Subject HHCTCP near HNL Runways 22L/22R

This memo is a review of the proposed Honolulu High Capacity Transit Corridor Project (HHCTCP) and the potential impacts to the FAA airspace surfaces that are in place to protect the approaches and departures to Runways 04L/22R and 04R/22L at Honolulu International Airport (HNL). This review was based in part on two drawings provided via email (dated June 11, 2009) titled HNL Runways with OFA, RSA and RPZ.pdf and HP029_Lagoon_R22R.pdf.

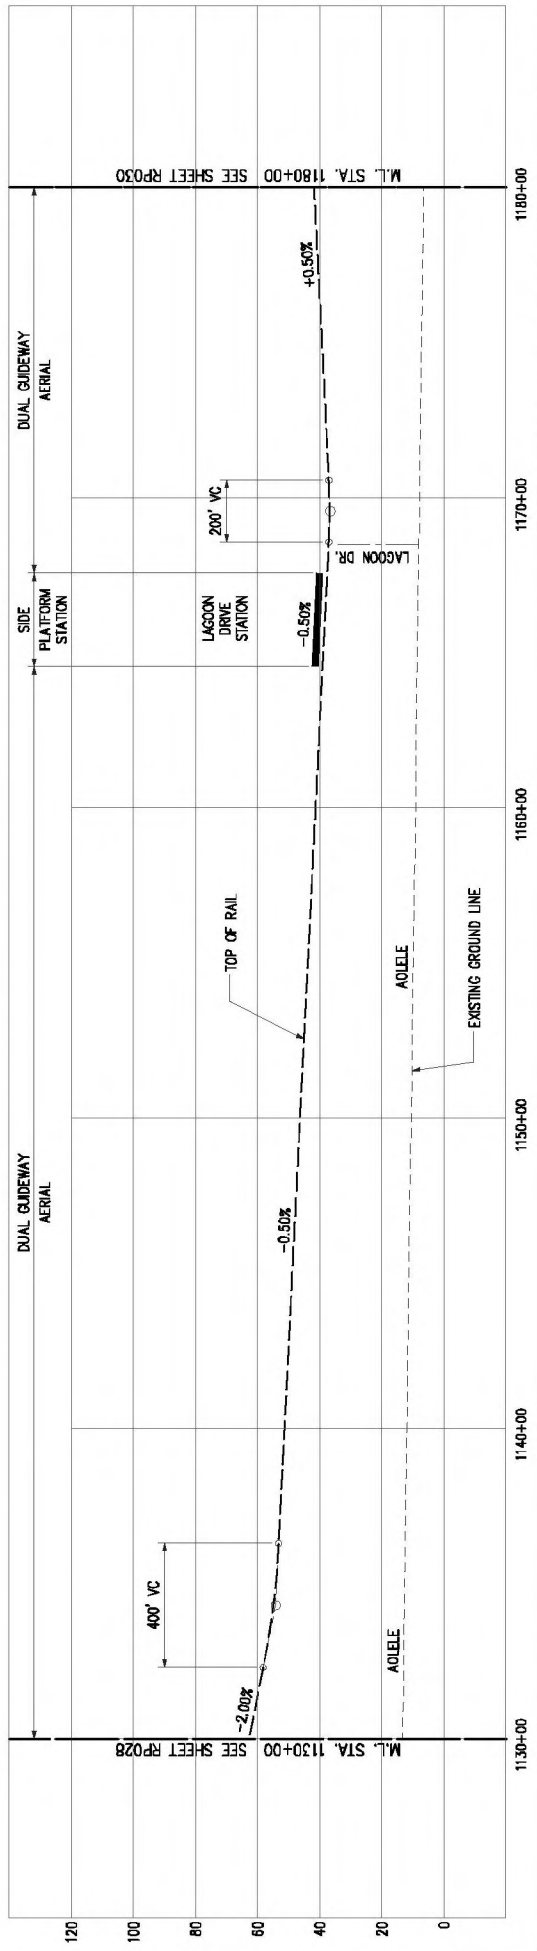
With regard to the drawings that were attached in an email sent on June 11, 2009, the Runway Protection Zones (RPZs) depicted on the drawing for Runways 04R/22L and 04L/22R do not appear to be shown correctly. Assuming that Runway 04L/22R is ARC C-III and Runway 04R/22L is ARC D-V, the RPZ, starting 200 feet from the runway end, should extend out 1,700 feet, have an inner width of 500 feet and an outer width of 1,010 feet.

We have redrawn the RPZs to the standards contained in FAA Ac 5300-13, *Airport Design*, for runways with a visual approach only with not lower than one mile visibility. With these dimensions, the RPZ for both runways extends well into the proposed HHCTCP and would add to existing non-conforming conditions.

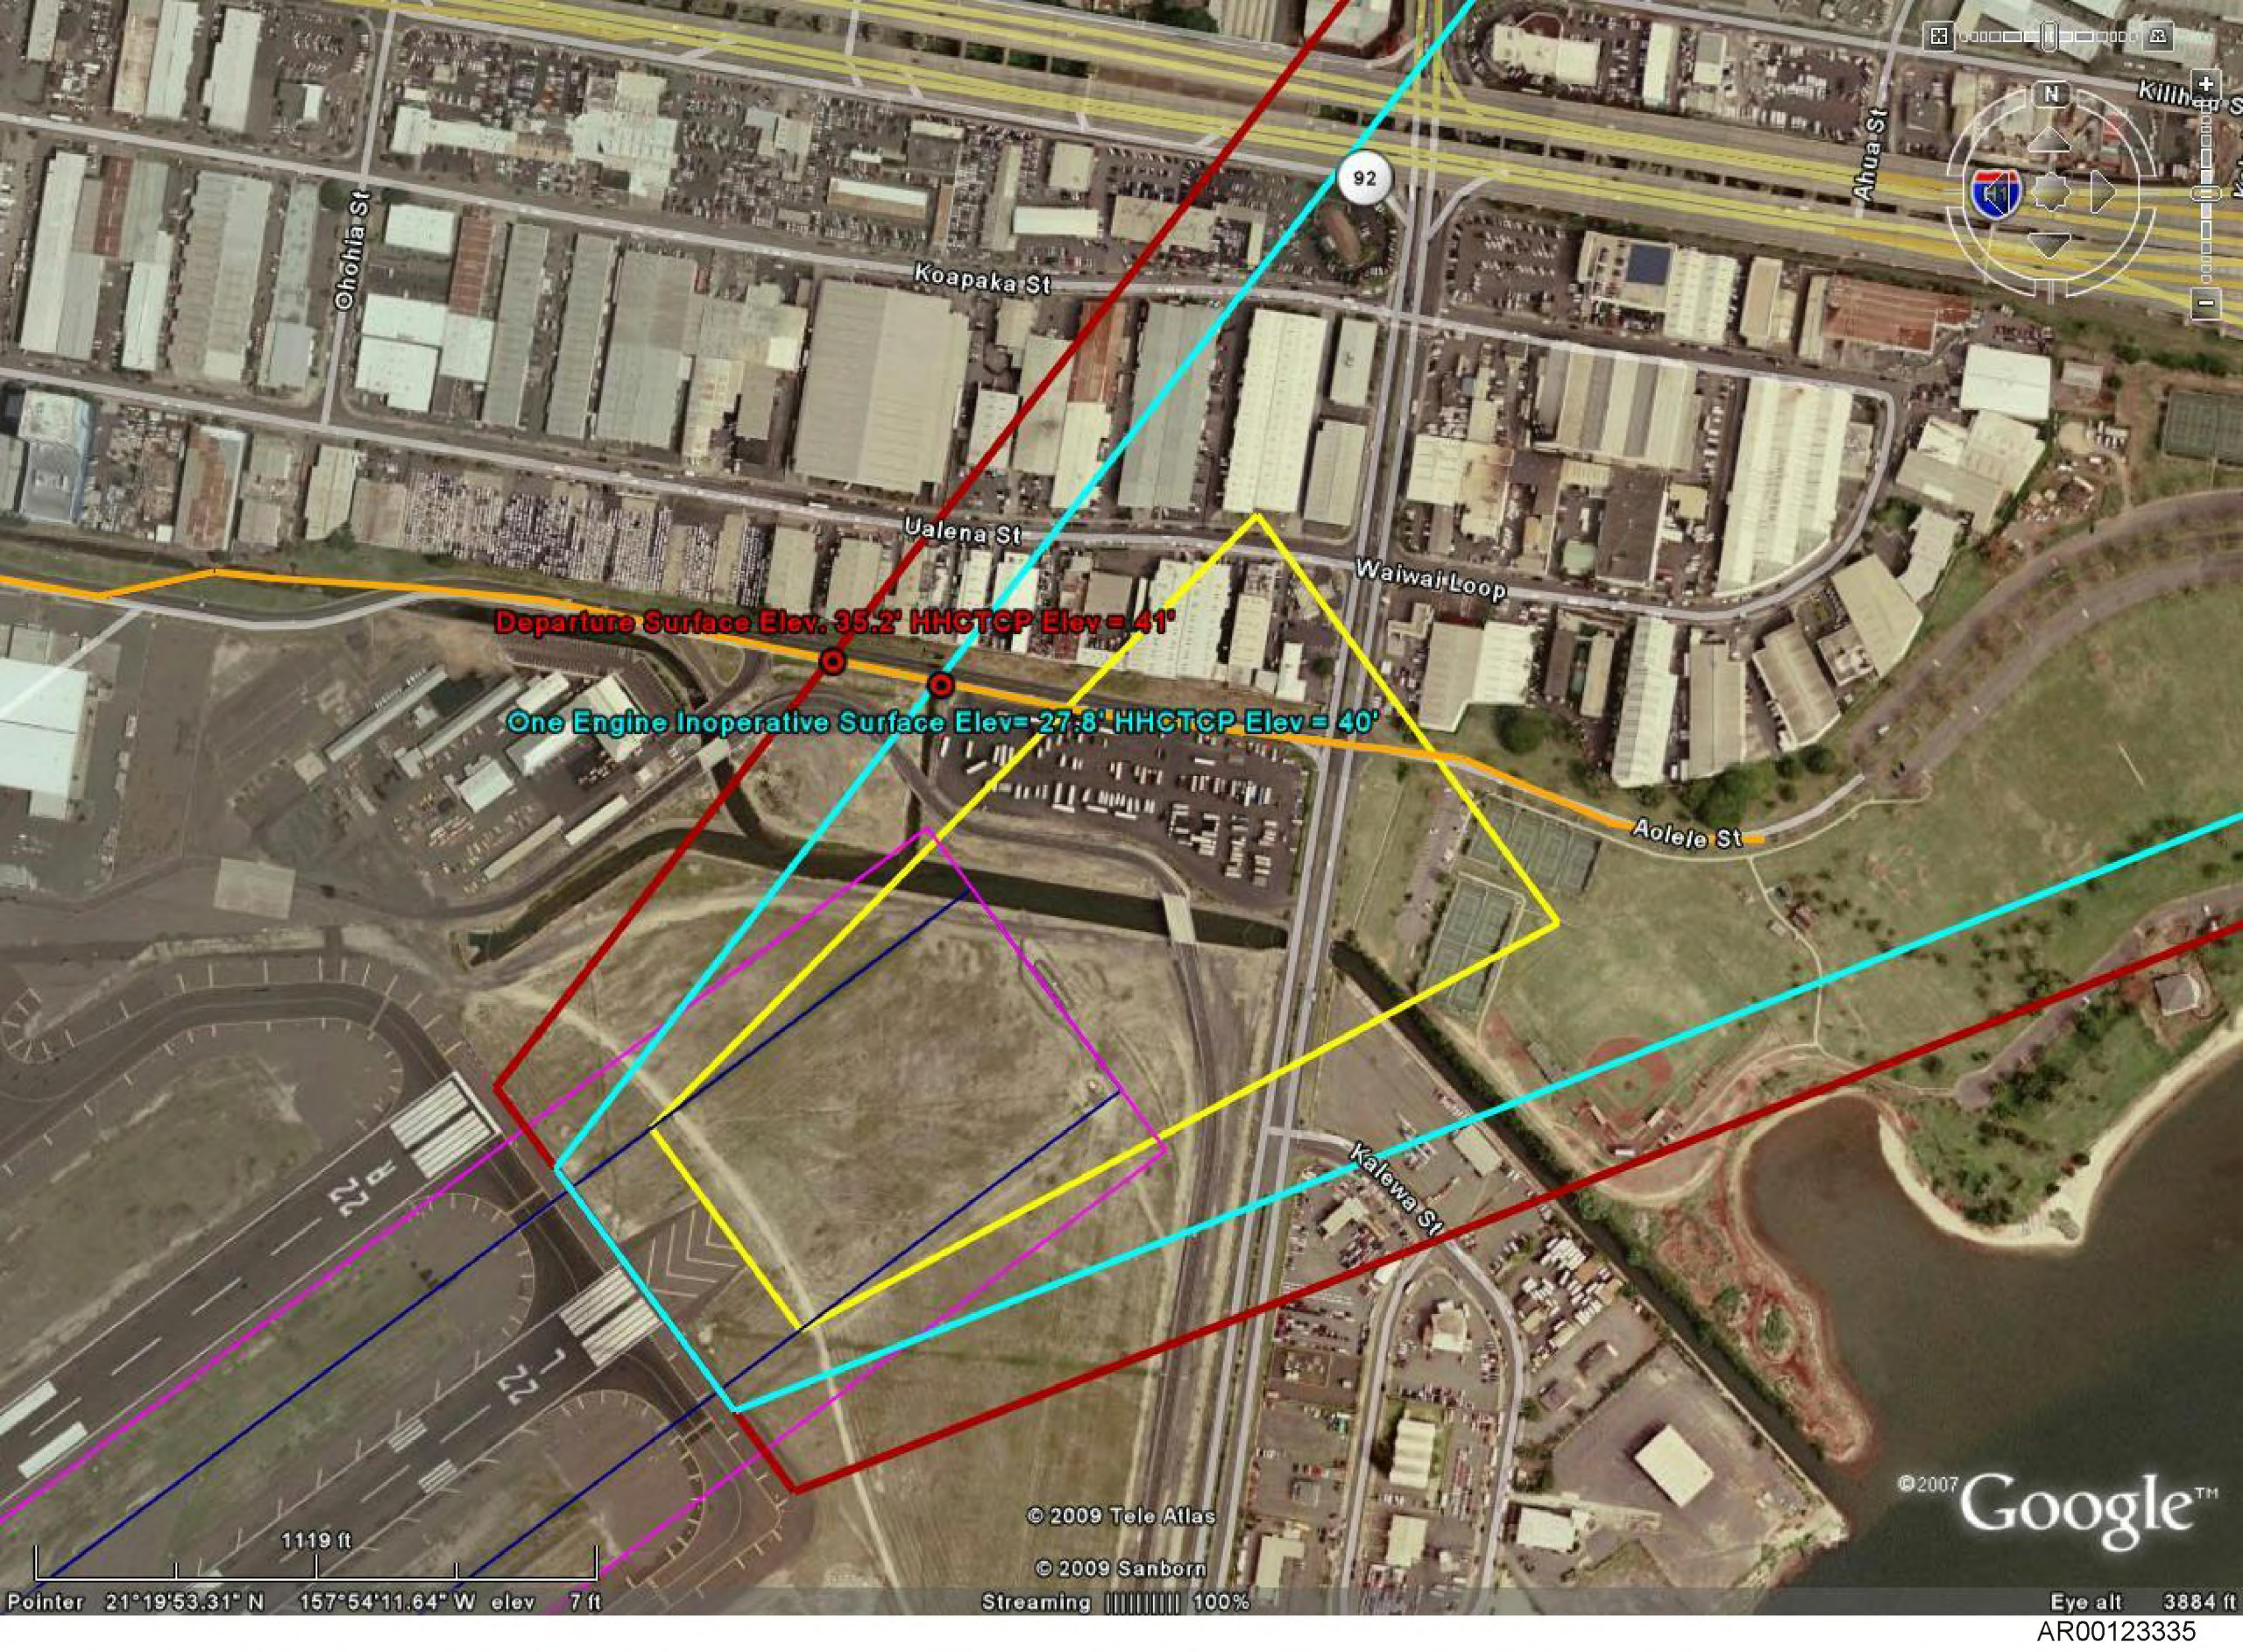
Departure Surface Elev. 35.2' HHCTCP Elev = 41'

One Engine Inoperative Surface Elev = 27.8' HHCTCP Elev = 40'

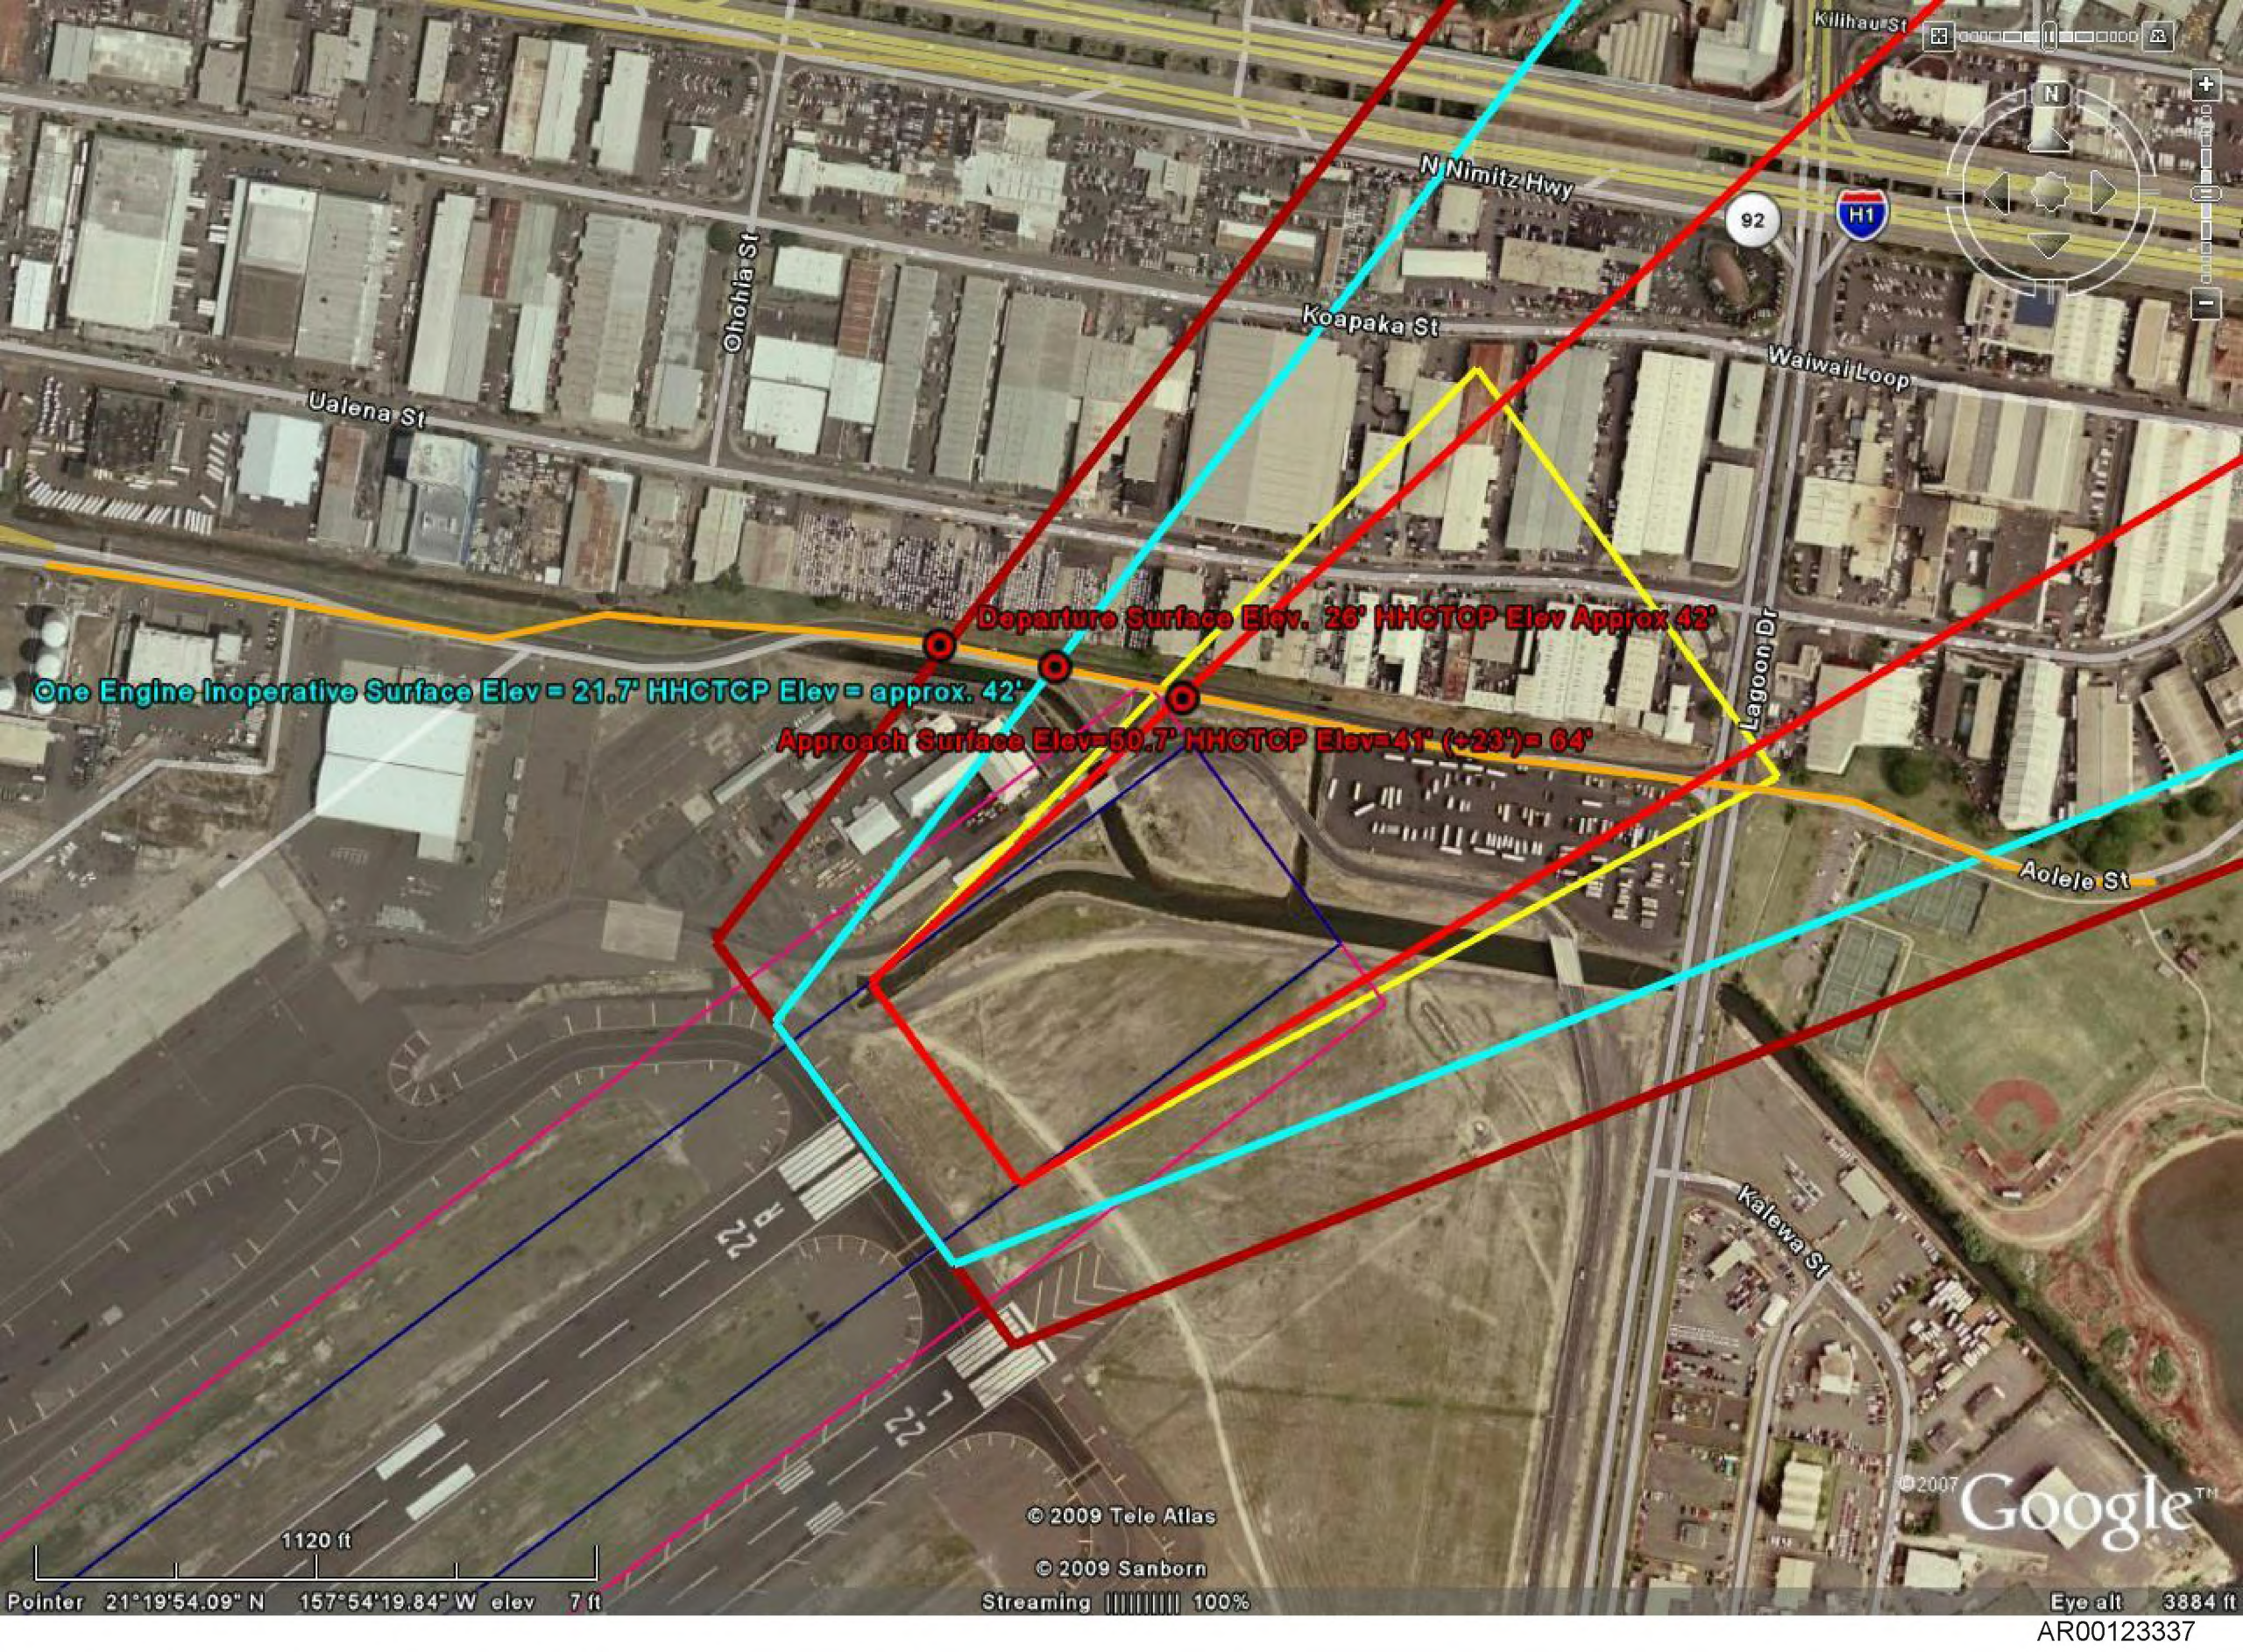
One Engine Inoperative Surface Elev = 21.7' HHCTCP Elev = approx. 42'

Departure Surface Elev. 26' HHCTOP Elev Approx 42'

Approach Surface Elev=50.7' HHCTOP Elev=41' (+23')= 64'
